***Southern California Edison Company***

Subject: Docket No. 50-206  
10 CFR 50 Appendix G, Fracture Toughness (GL 88-11)  
San Onofre Nuclear Generating Station  
Unit 1

RESPONSE TO NRC REQUEST FOR ADDITIONAL INFORMATION  
REGARDING UNIT 1 RESPONSE TO GENERIC LETTER 88-11

FIGURE 1. Predicted Decrease In Upper Shelf Energy For SONGS1 Per Regulatory Guide 1.99 Rev. 2

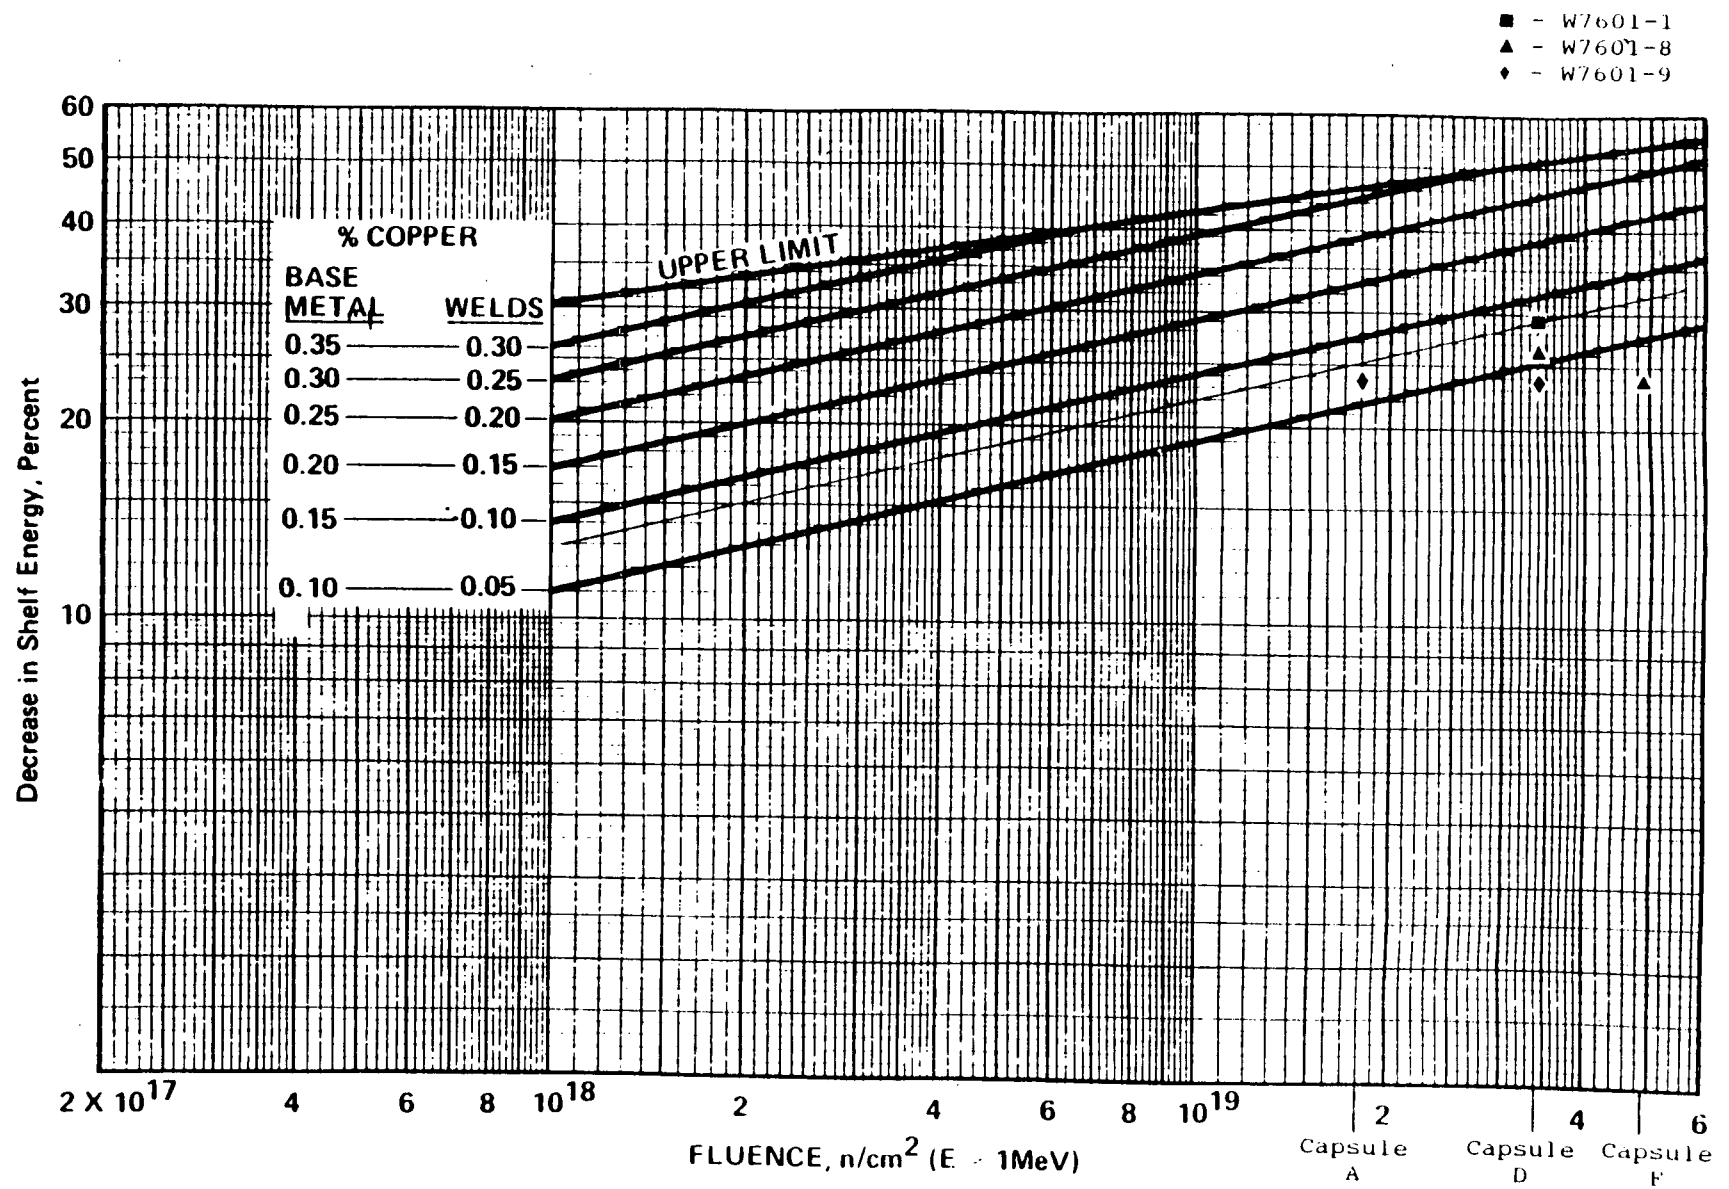
With regard to charpy upper shelf energy, please provide the results of your calculations using:

- a. The methods of R.G. 1.99, Rev. 2
- b. The alternate method that was discussed which credits saturation effects. In this case, also provide supporting details for your conclusions.

At the request of the NRC, the beltline USE was also evaluated using R.G. 1.99, Rev. 2. SCE used Section C.2 which credits surveillance data for determining the USE. Updated fluence data, surveillance data from the SONGS 1 program, and the methodology of Section C.2 were used for determination of USE. SONGS 1 surveillance data is listed in Table 2. Data for all 3 surveillance capsules have been grouped and plotted in Figure 1.

Bounding the data in Figure 1 and using the lowest unirradiated transverse USE (71.5 ft-lbs), plate W7601-9 is limiting and would be predicted to currently have an USE of 53.1 ft-lbs. USE for this plate would be predicted to drop below 50 ft-lbs at 24.7 EFPY (see Table 3) based on R.G. 1.99, Rev. 2, which is beyond the current projected plant EOL.
